TECHNICAL SERVICE BULLETIN No.JTB00191/2010 01 April 2010

Subject/Concern:	Glove Compartment Lid is Not Damped Upon Opening
Model:	
XK Range	VIN Range: B00001 Onwards
Markets:	All
Section:	501-00
Summary	
<p>The glove compartment lid is not damped upon opening.</p> <p>Cause: The glove compartment lid damper cord retaining tab has come away from the glove compartment housing. Suggested Customer Concern Code - B85.</p> <p>• The split pin/cotter pin (2mm x approx 30mm) must be locally sourced.</p> <p>Action: Should a customer express concern, follow the Service Instruction outlined below.</p>

E129721

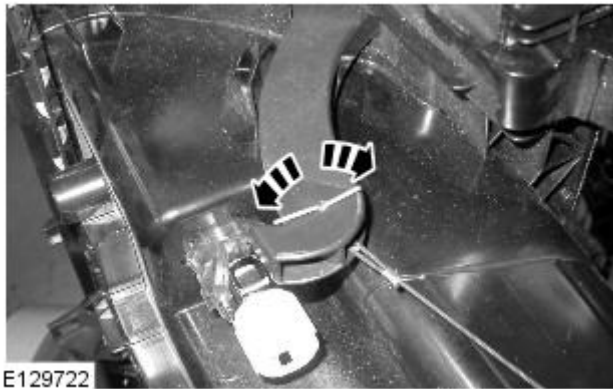
3. Install the glove compartment lid damper cord looped end into the damper arm (1 in E129721).

1. Install the (locally sourced 2mm x approx 30mm) split pin/cotter pin in to the drilled hole and through the damper cord looped end (2 in E129721).
